RE: Comments on the Proposed United States Triumphal Arch, Memorial Circle, George Washington Memorial Parkway, Columbia Island

Re: New Monumental Arch Project, NCPC File Number: 8778

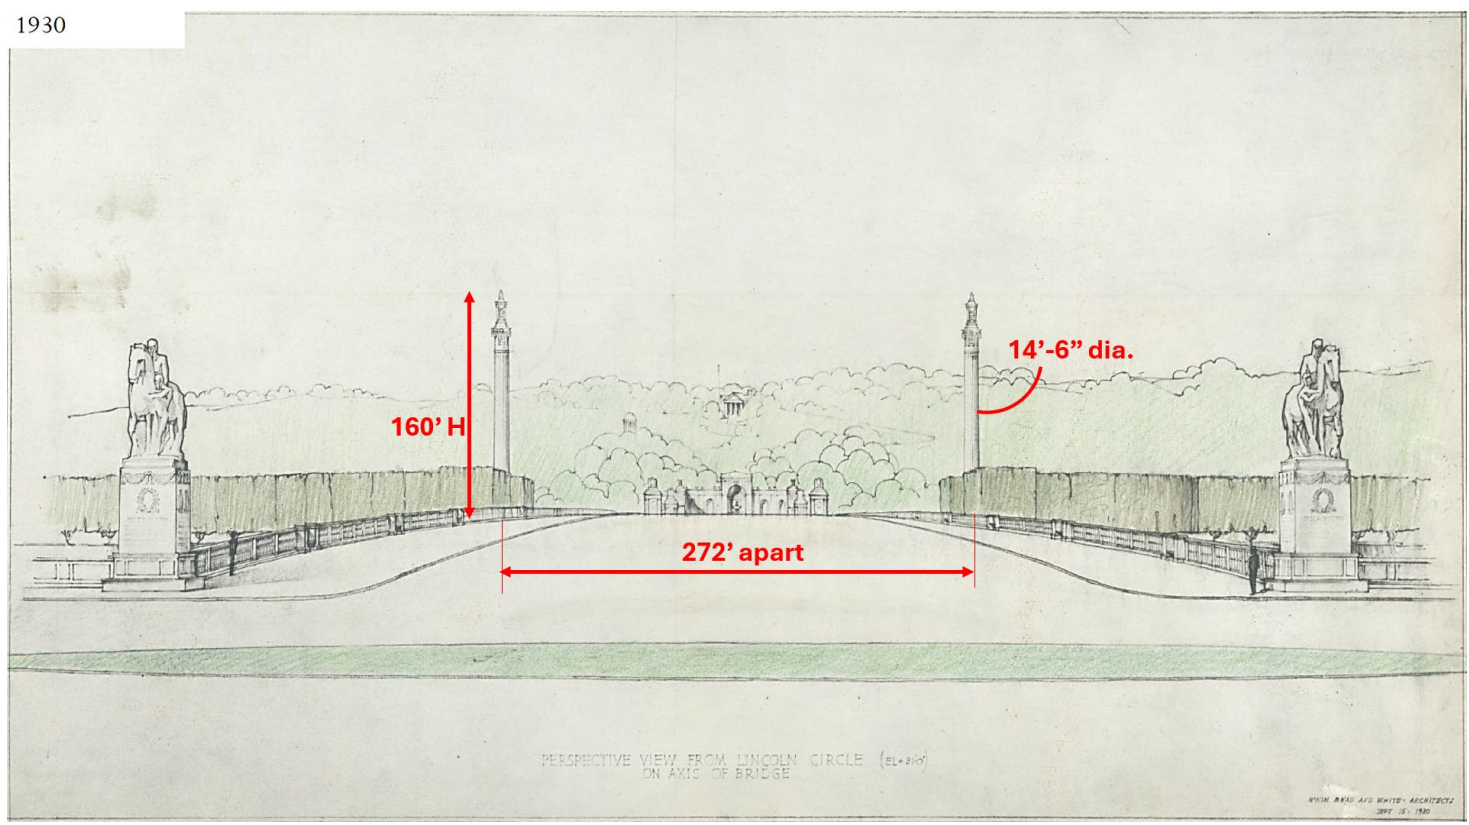
The proposed arch has been touted by the applicant as necessary to compete with other cities with its immense SIZE as a prerequisite to be *larger* than any other monumental arch in the World. This justification assumes that physical scale and DOMINANCE are more essential than meaning, or the appropriateness of scale to this very solemn setting and quite specific context.

ALTERNATIVE PROPOSAL

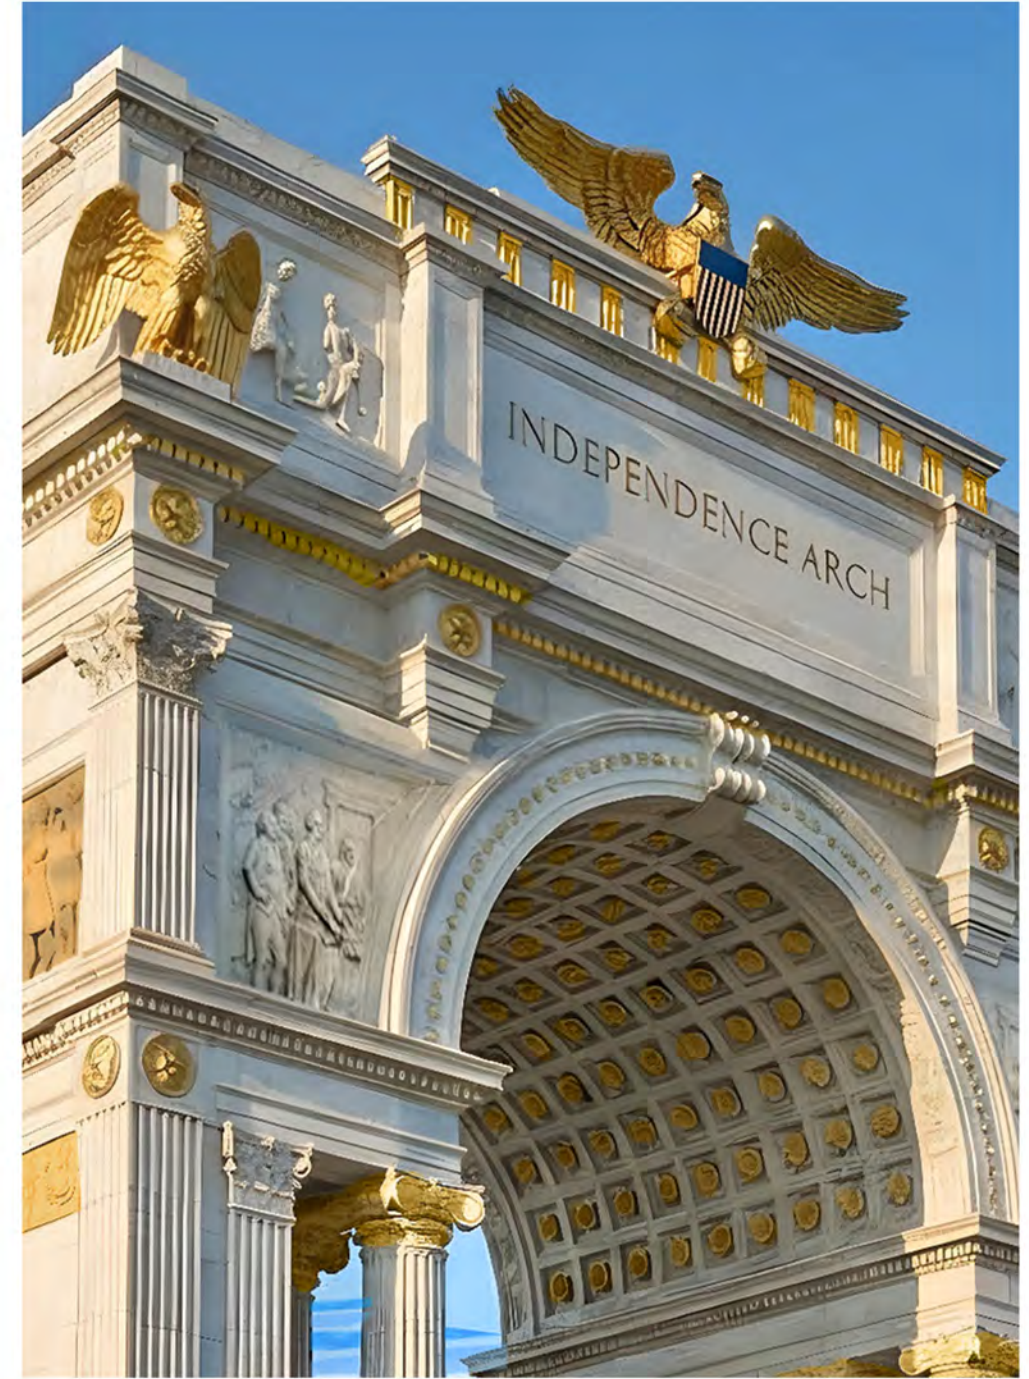
*Reduced base mass proportion is about
30% Solid to 70% void
- More opening, more visibility -
